# HOME2 SUITES FLOWOOD, MS 5th FLOOR PANELS

- ☒ REVIEWED  
☐ REVIEWED AND NOTED  
☐ REVISE AND RESUBMIT  
☐ REJECTED  
☐ RETURNED - SUBMITTAL NOT REQUIRED

## CONTENTS:

PNL.#: 5-06d QTY: 2

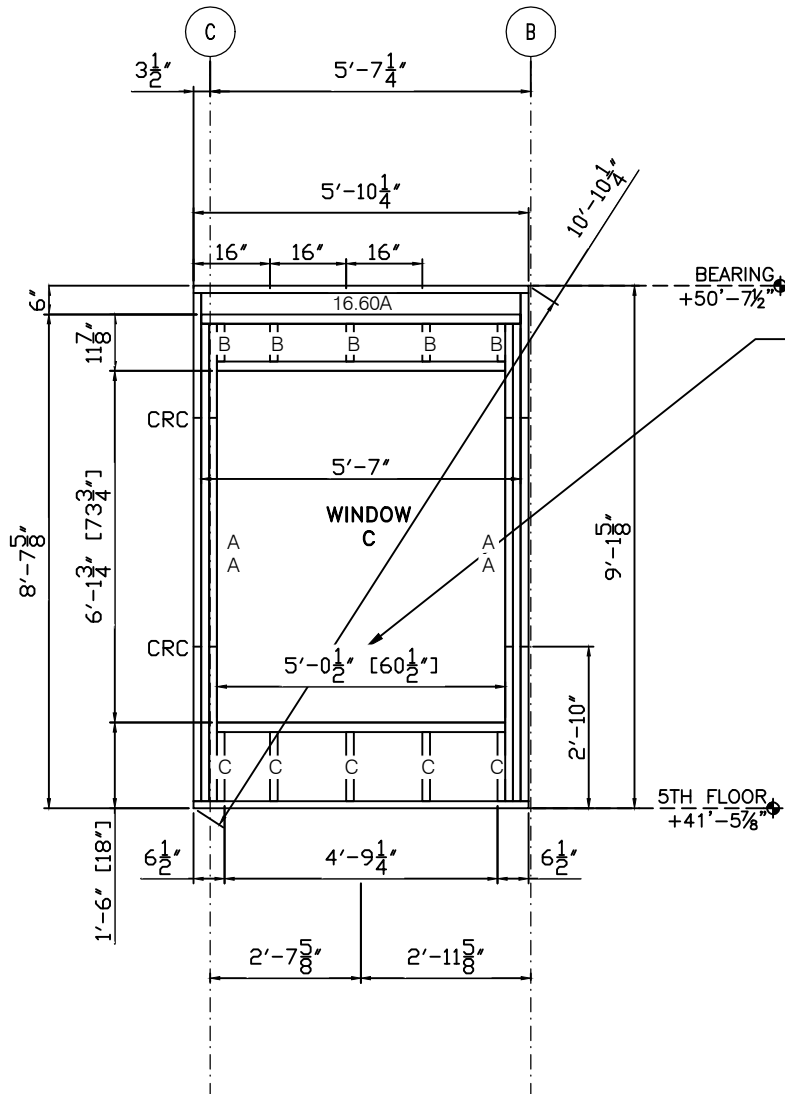
NOTE: BECAUSE OF REQUIRED SUPPORT STUDS, 60 1/2\"

PNL.#: 5-22c QTY: 1

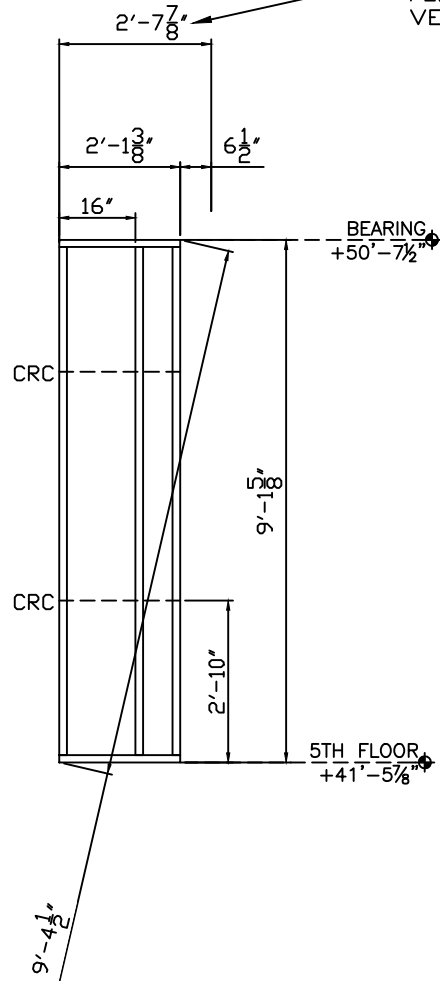
NOTE:  
PLEASE  
VERIFY

PNL.#: 5-27e QTY: 2

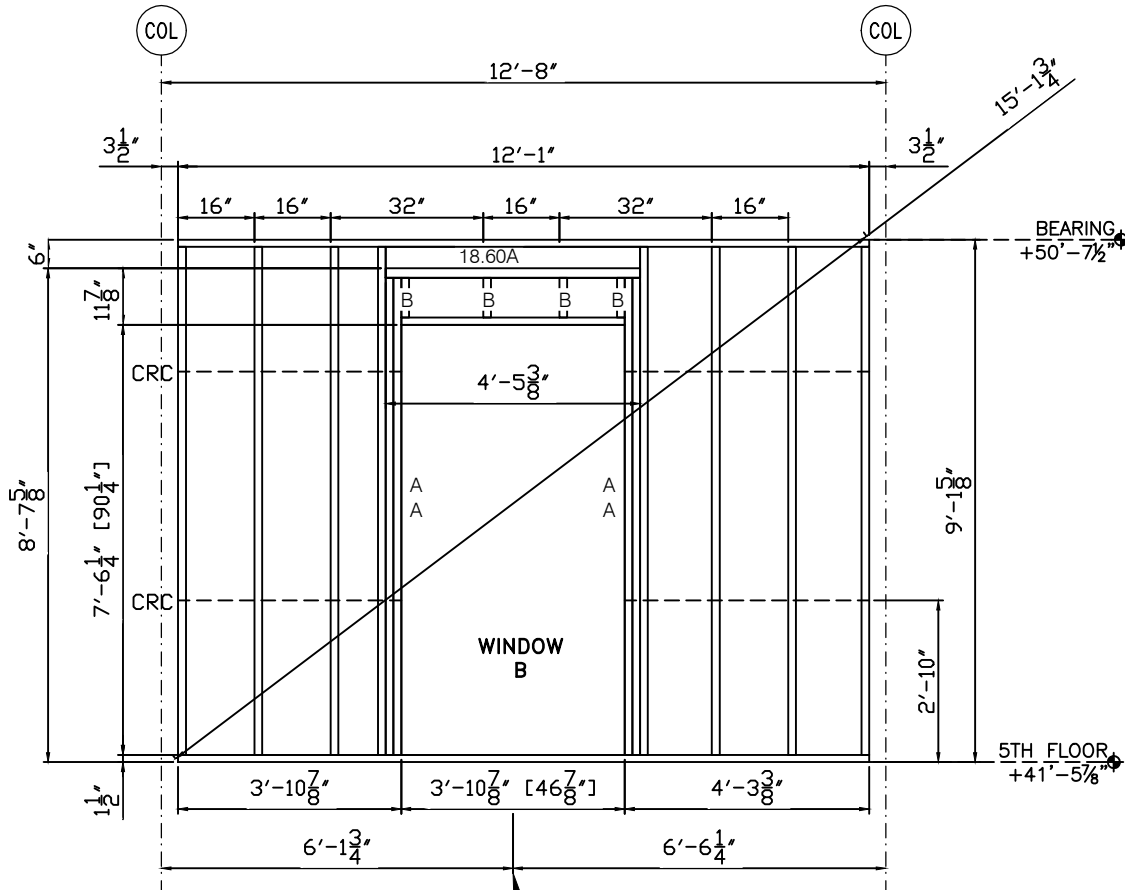
NOTE:  
THIS WINDOW NOT CENTERED  
TO ALIGN WITH WINDOW BELOW.  
SEE 1-51e.

PNL.#: 5-28e QTY: 1

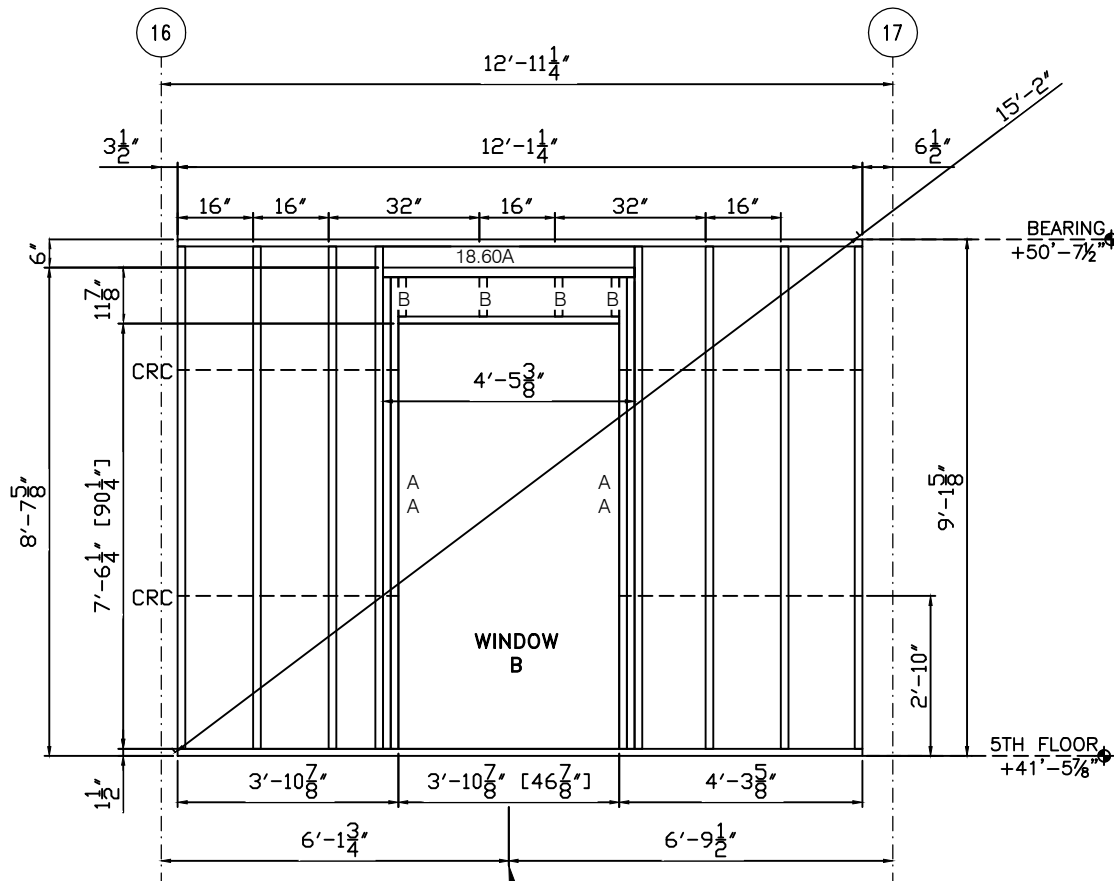
NOTE:  
THIS WINDOW NOT CENTERED  
TO ALIGN WITH WINDOW BELOW.  
SEE 1-51e.

PNL.#: 5-48c QTY: 2

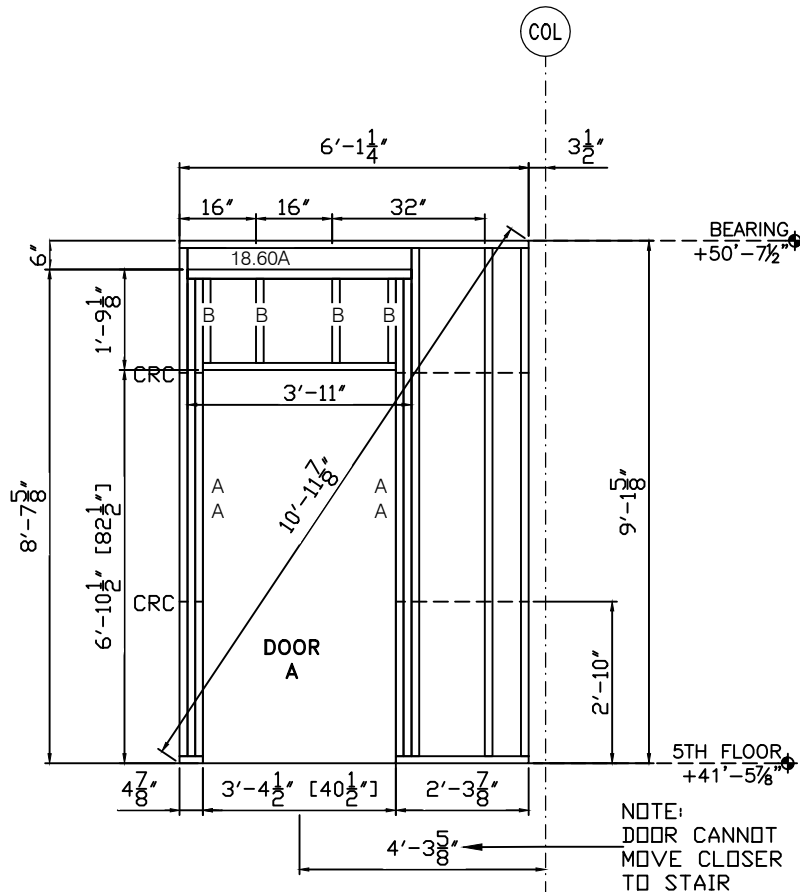
NOTE:  
DOOR CANNOT  
MOVE CLOSER  
TO STAIR
